RE: **Lot 4 Block 8 Volcano Cliffs Unit 22 SAD 228
6416 Canavio Rd. NW
Grading and Drainage Plan
Engineers Stamp Date 5/12/2020 (D10D003E4)**

Based upon the information provided in your submittal received 6/17/2020, this plan is approved for Grading Permit.

DESIGNED SEG	RESPEC	DATE	6.02.2020
DRAWN	JT	CHECKED	SEG
		5971 Jefferson Street Suite 101 Albuquerque, NM 87110 Water and Natural Resources respec.com 505.253.9718	
THIS DRAWING IS INCOMPLETE AND NOT TO BE USED FOR CONSTRUCTION UNLESS IT IS STAMPED, SIGNED AND DATED.			
PROJECT NAME: VOLCANO CLIFFS 6416 CANAVIO RD NW PULTE ID 19			
SHEET TITLE: GRADING AND DRAINAGE PLAN			
SUBMITTED FOR: GRADING PERMIT			
SHEET NUMBER: 1 OF 1

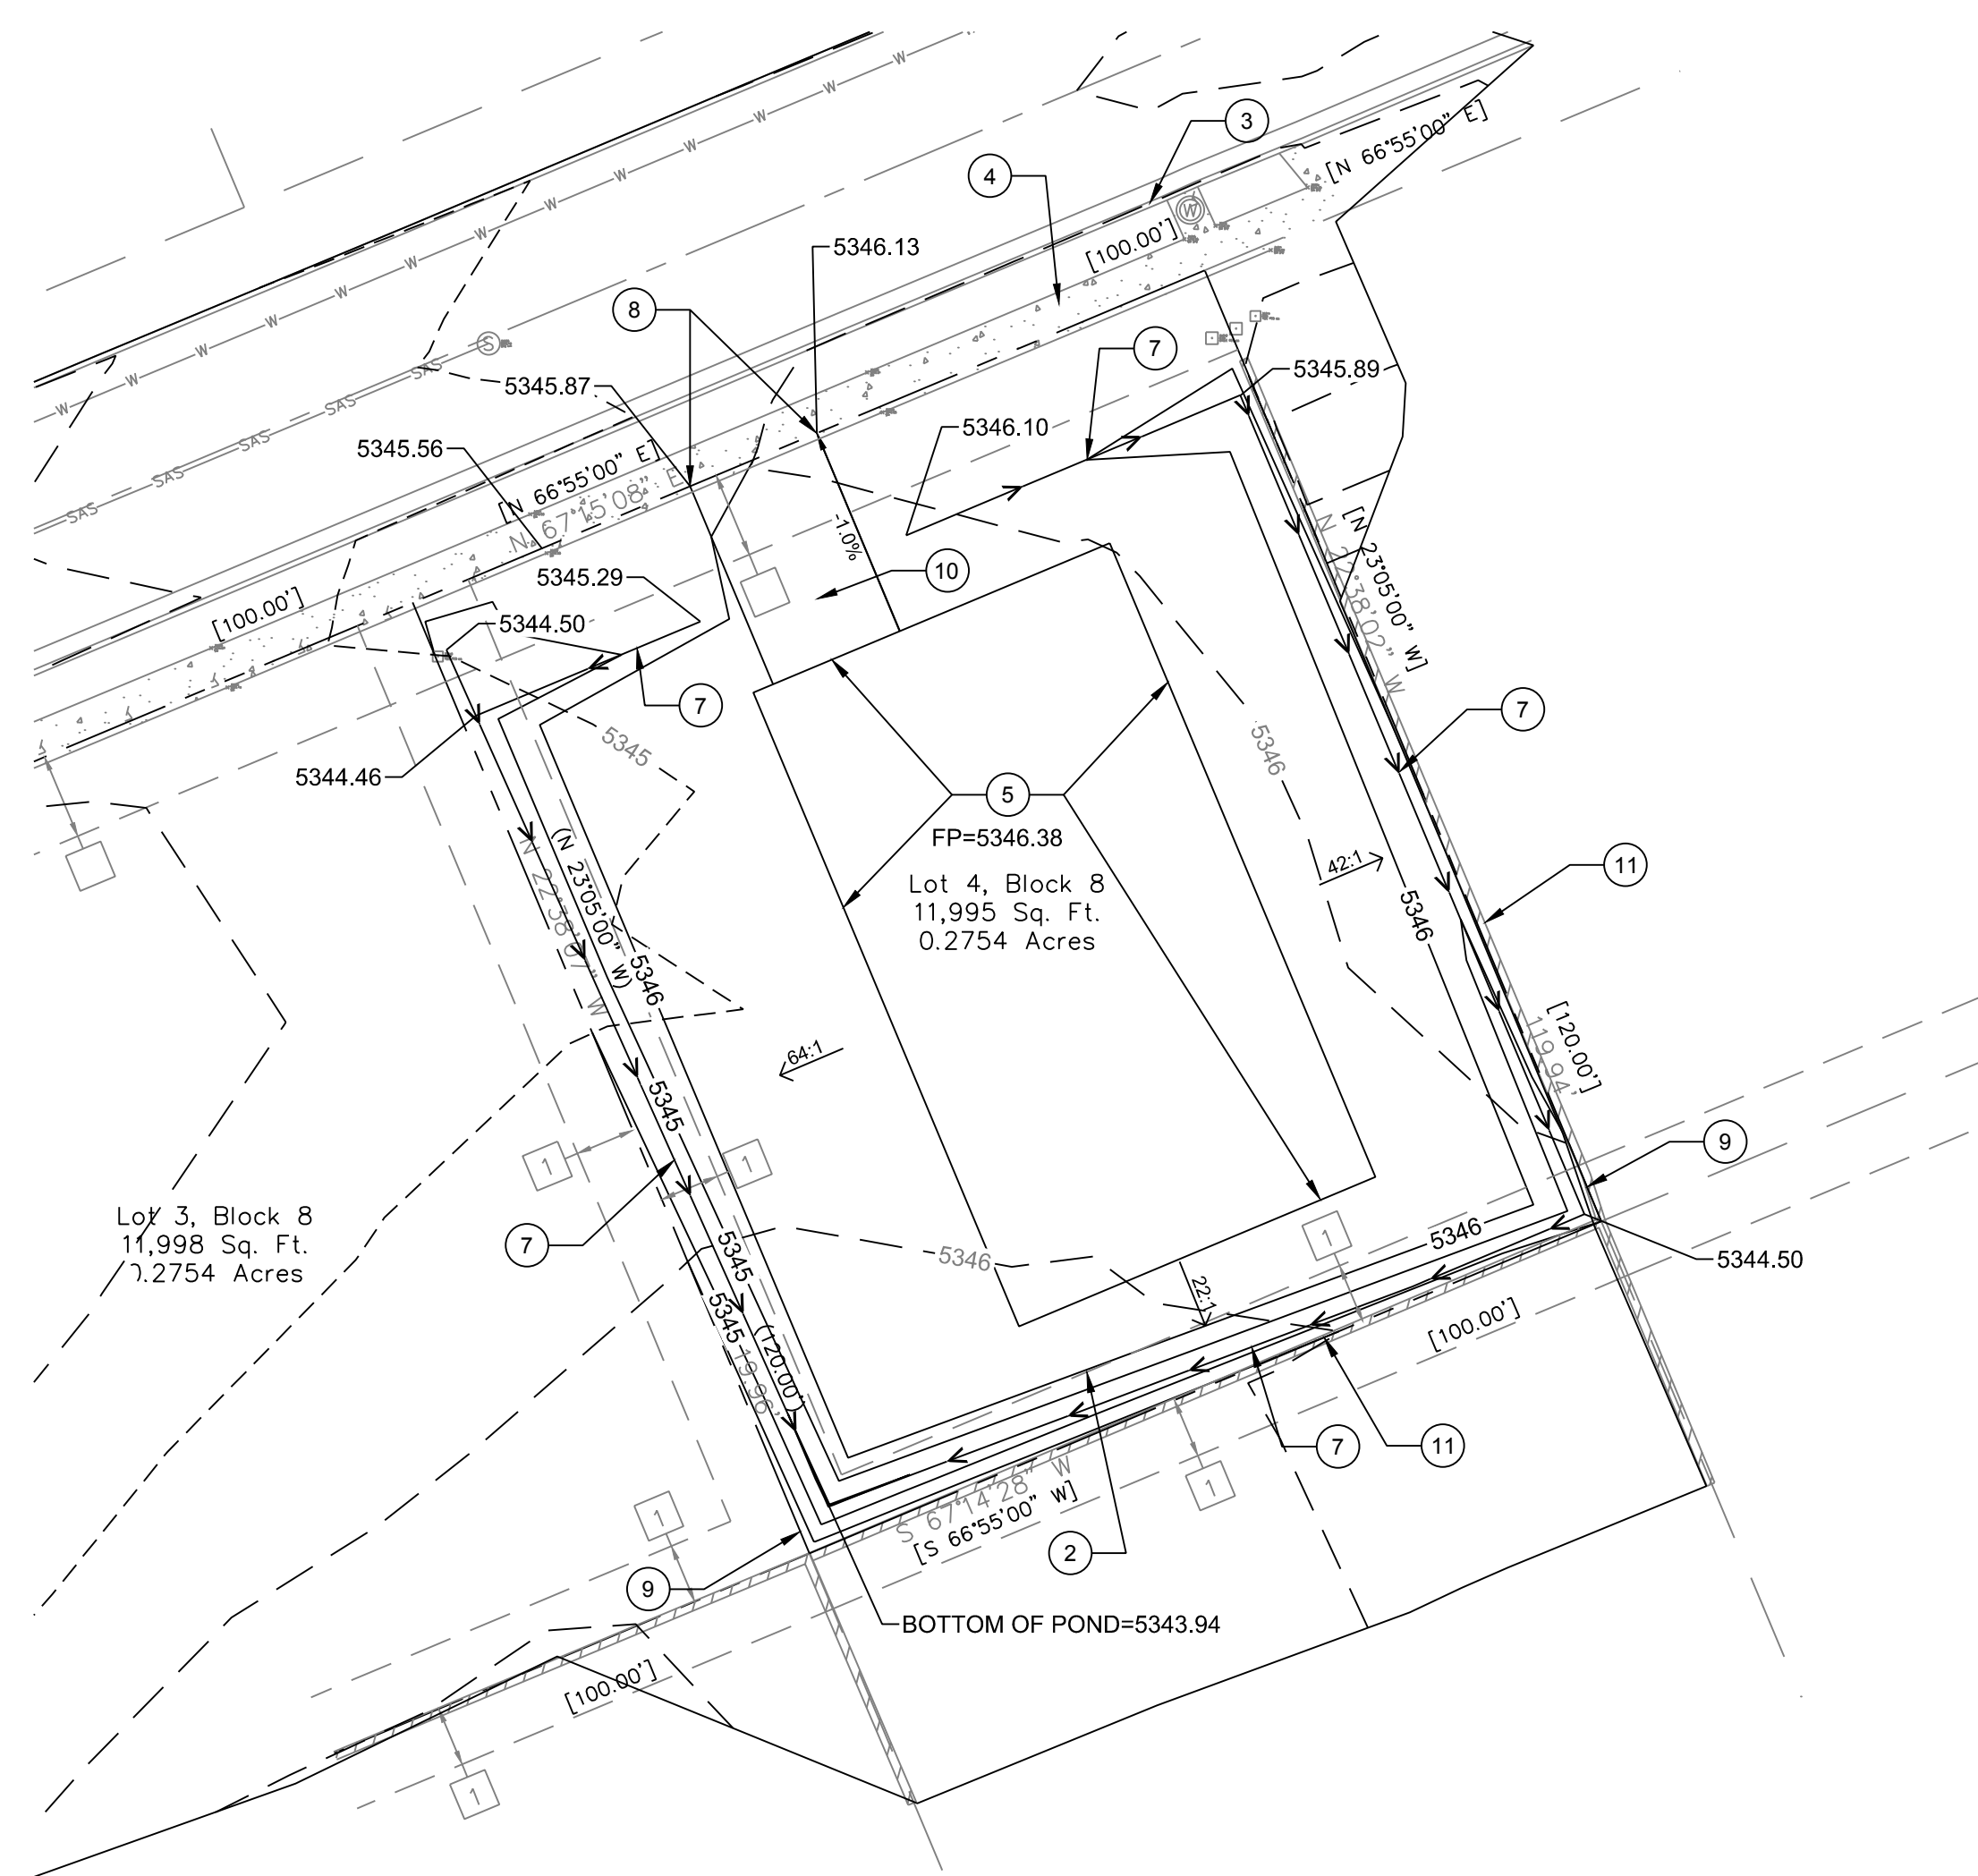
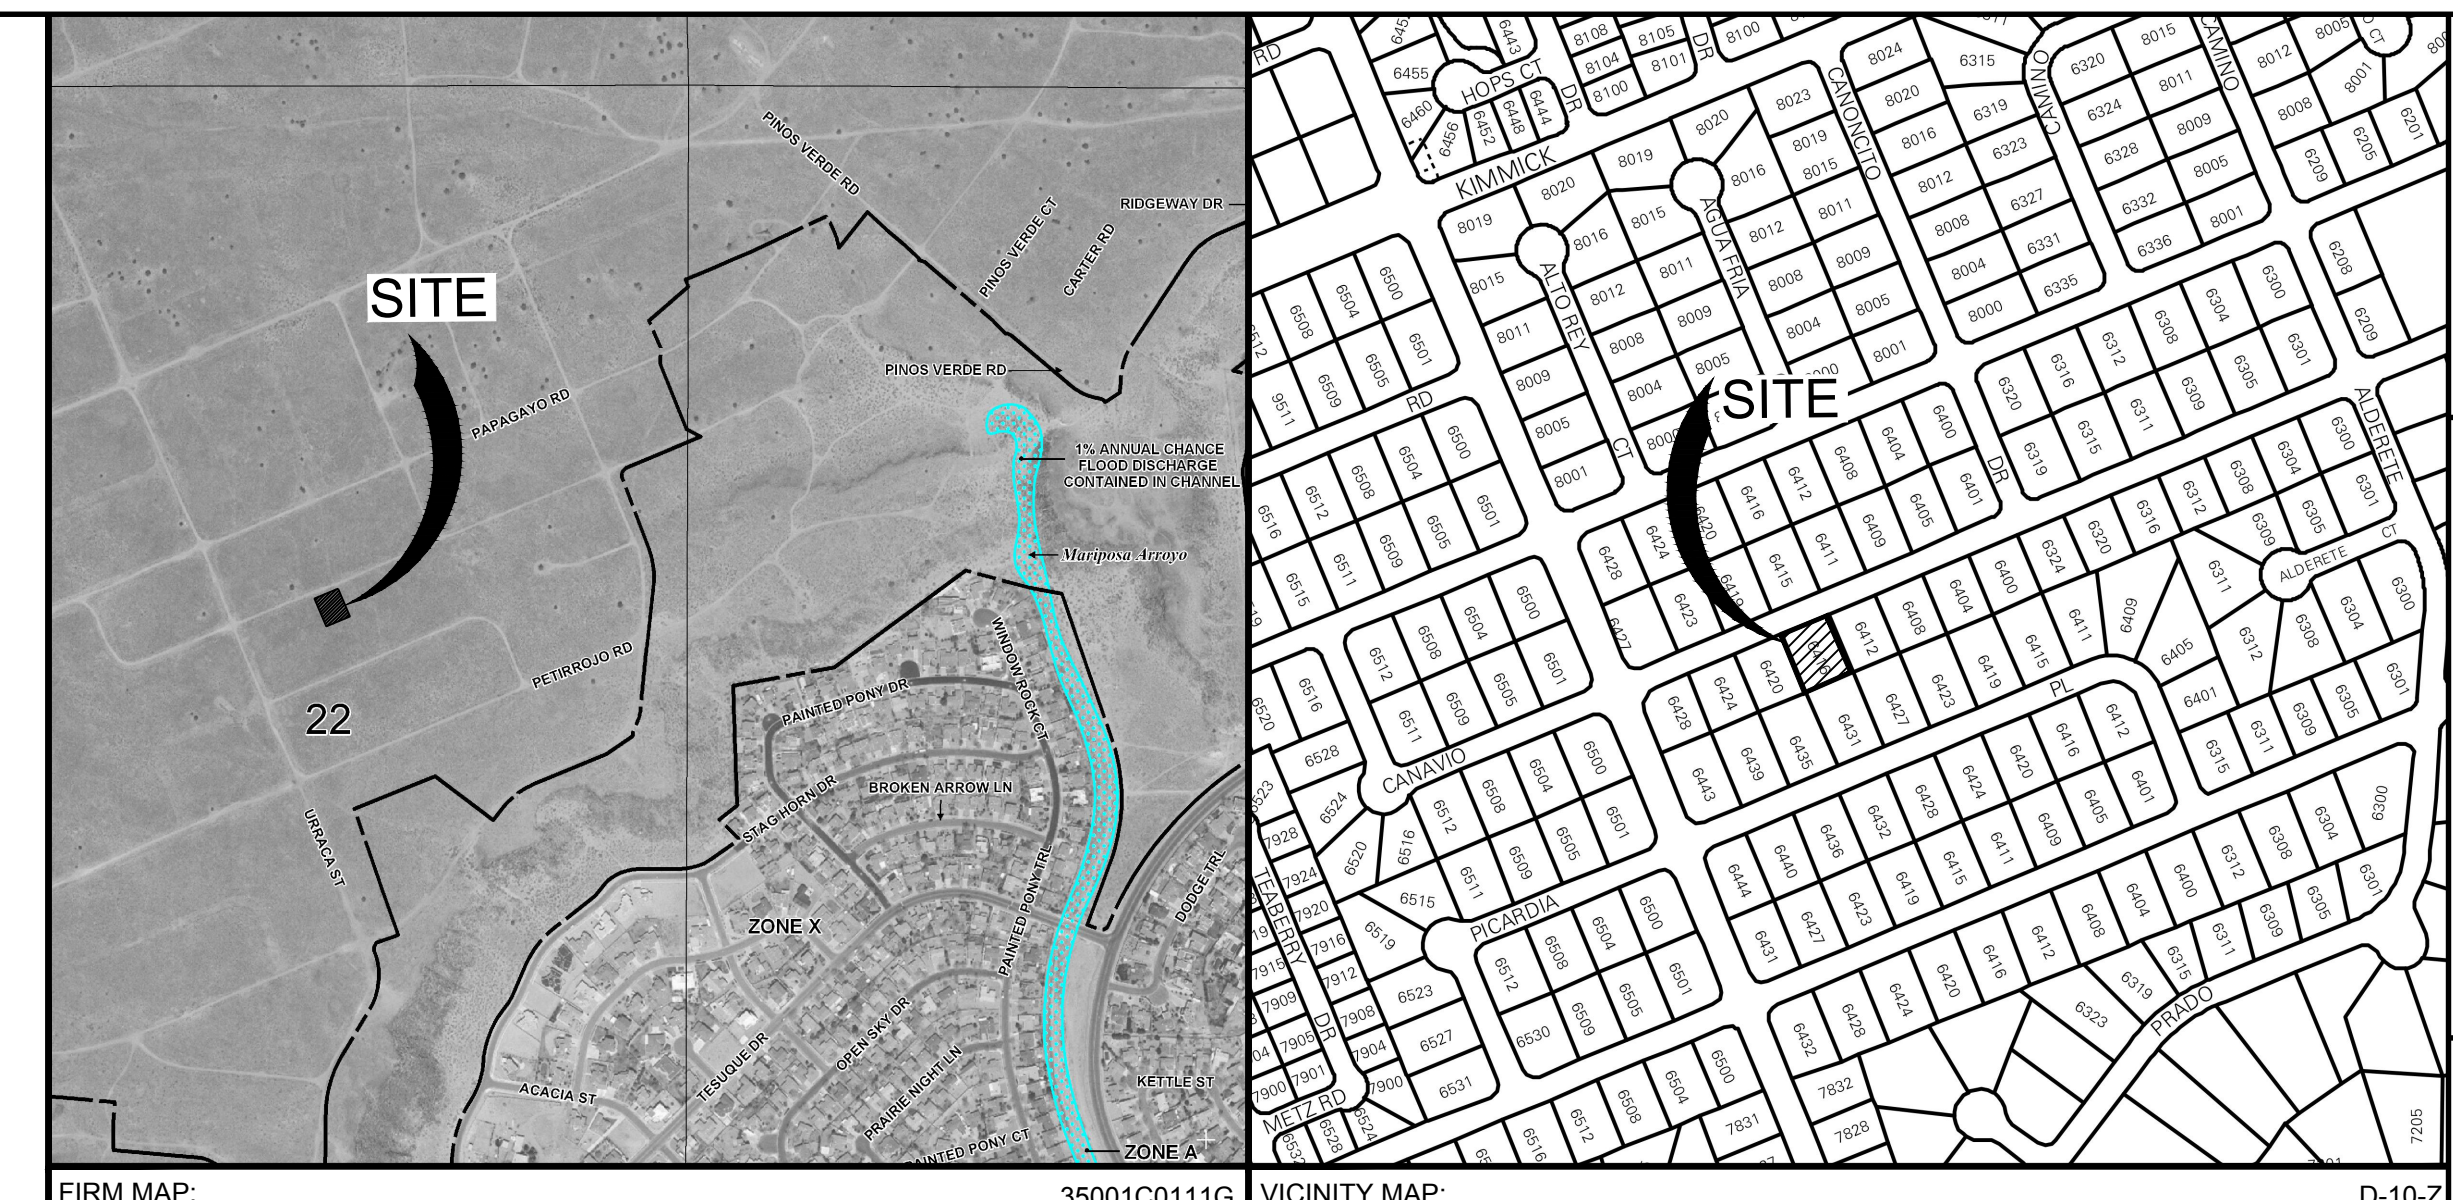
Prior to Building permit approval a Pad Certification will be required, provided by the Engineer or a registered Land Surveyor.

Reiterate to the Owner/Contractor that a separate permit for a garden/retaining wall must be obtained with the approved G&D plan and Pad Certification. **Also, if a swimming pool is to be placed the grading and drainage plan will change and will need to be resubmitted.**

Prior to Certificate of Occupancy release, Engineer Certification per the DPM checklist will be required.
